## ADDENDUM NO. 1

Board of Education – New Parking Lot

San Bernardino City Unified School District

RCA Project No. 1-78-60

TITLE SHEET

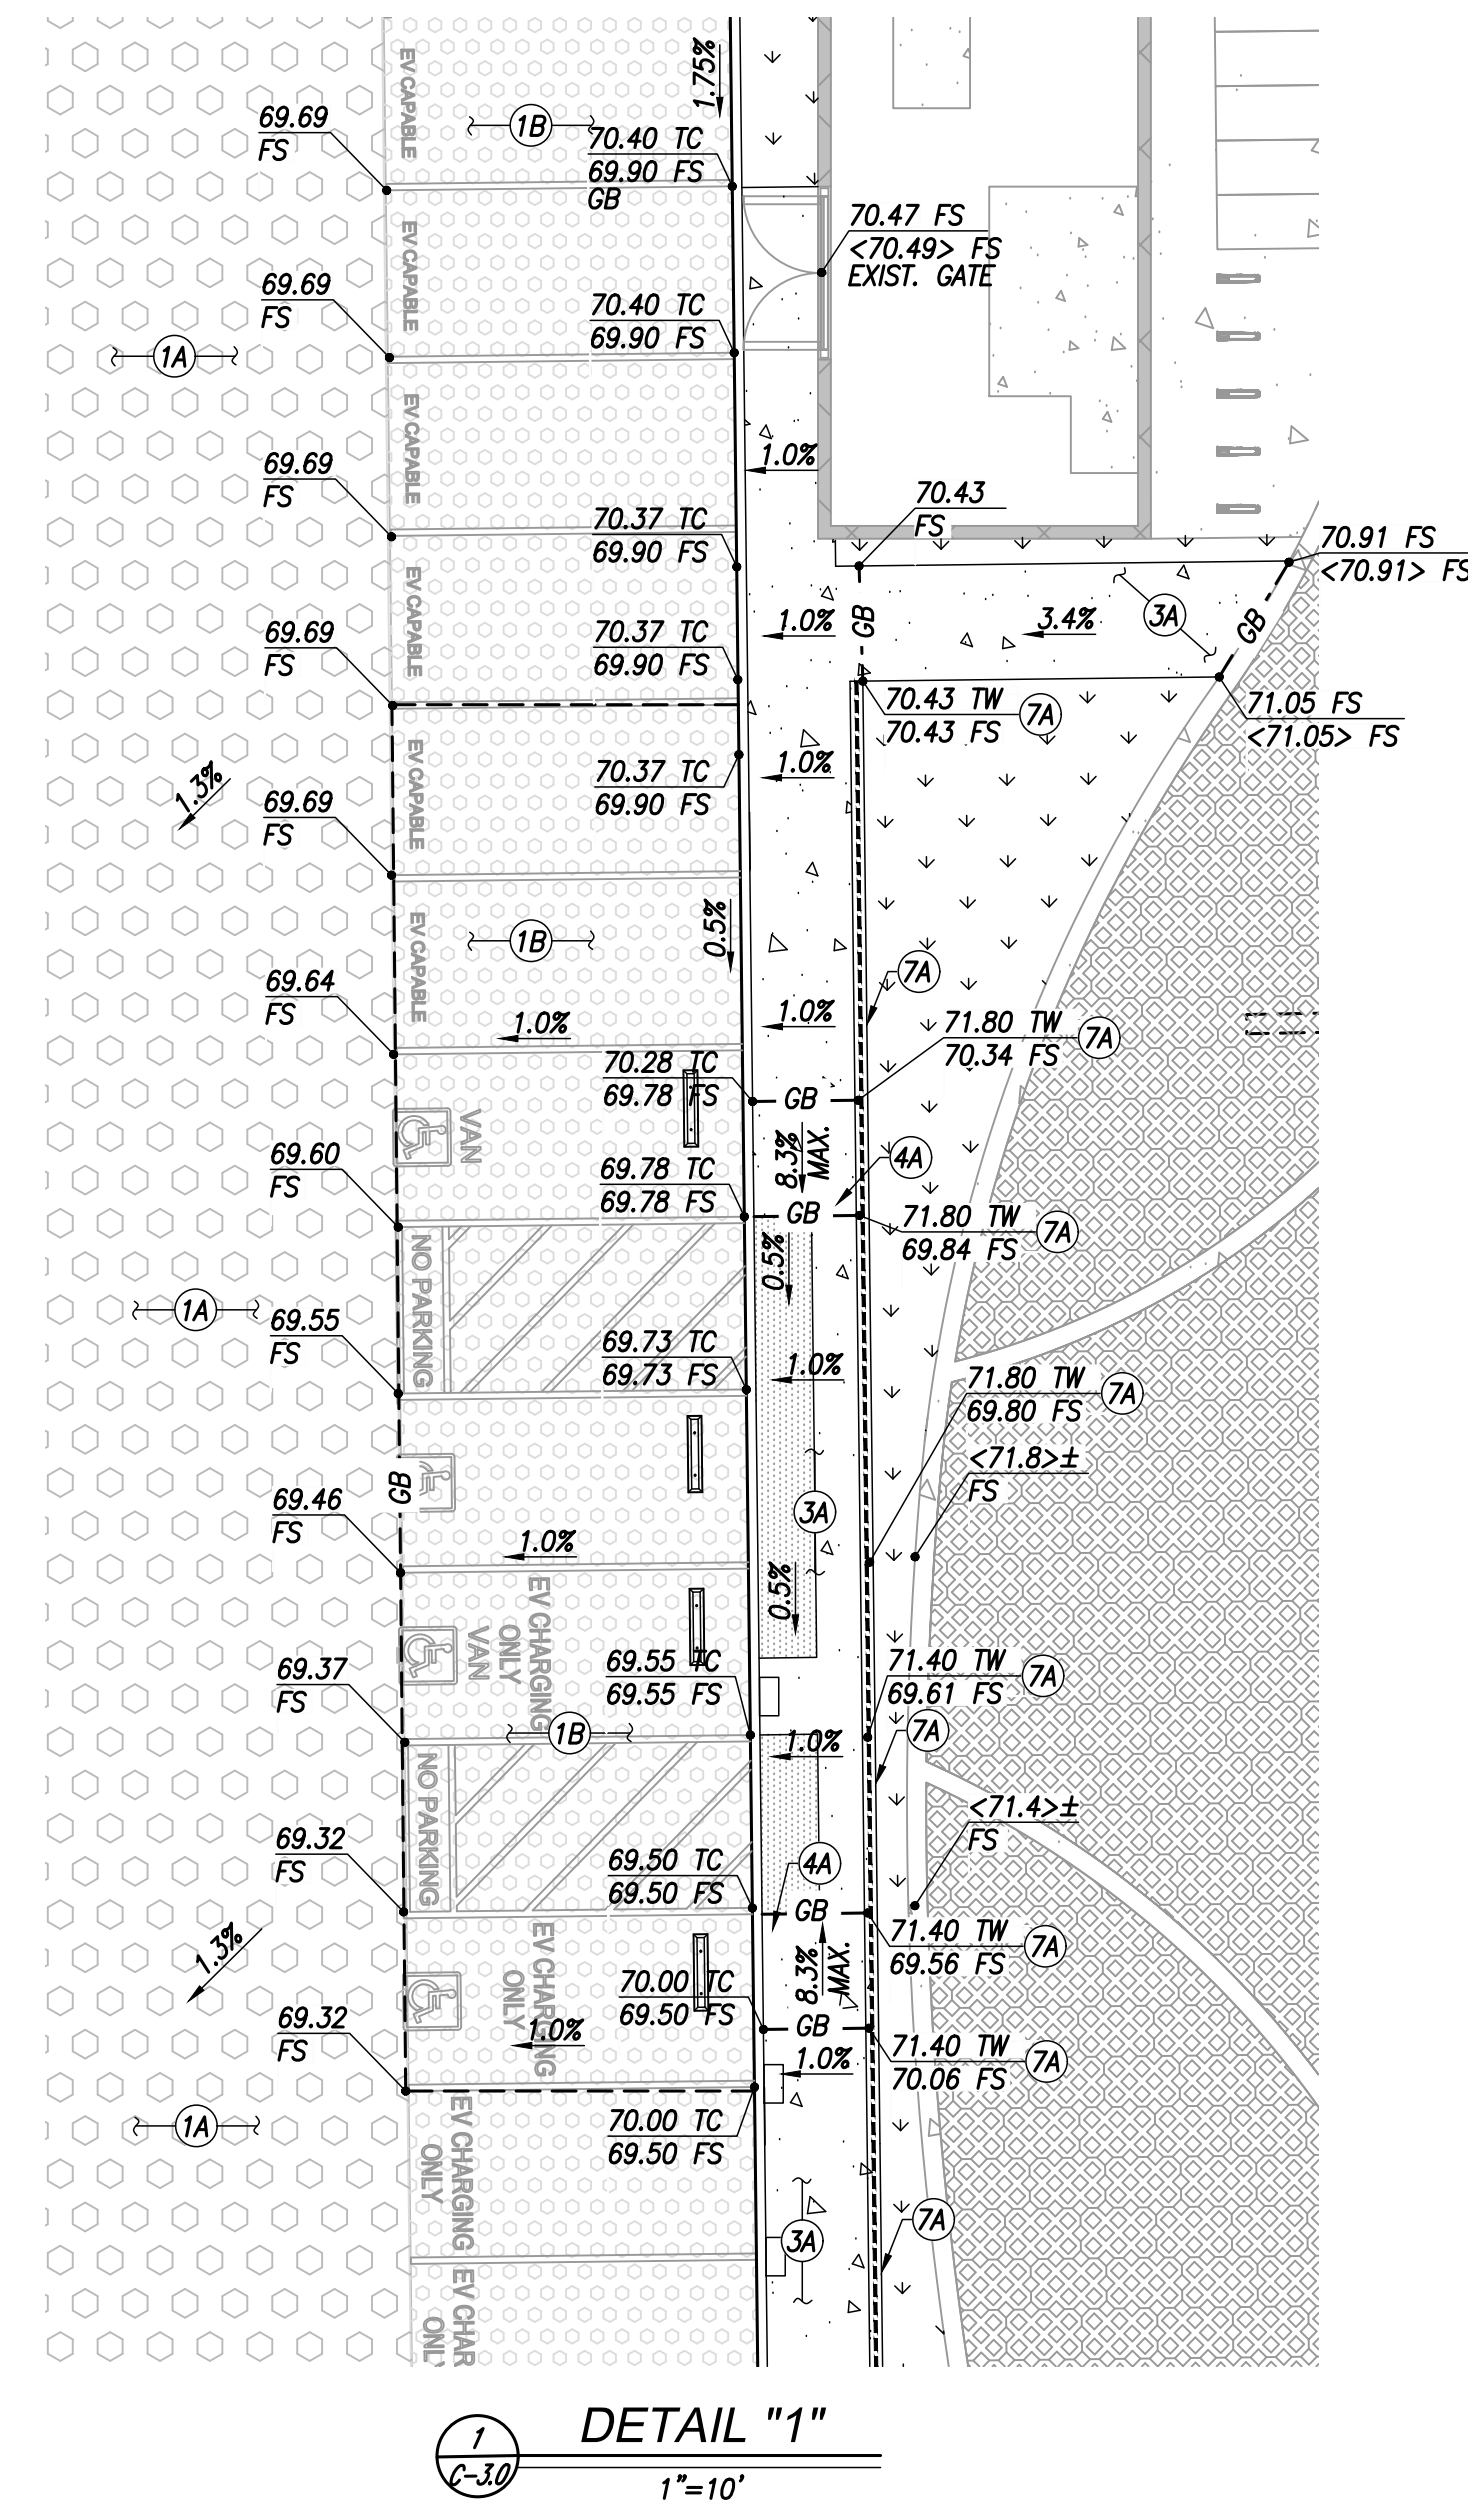
- Item No. 1.2      Reference Sheet C-1.0 – TITLE SHEET  
1.2.1      Replace Sheet C-1.0 and revise per clouded areas listed below:  
                    (a)    Added existing spot elevations to legend.
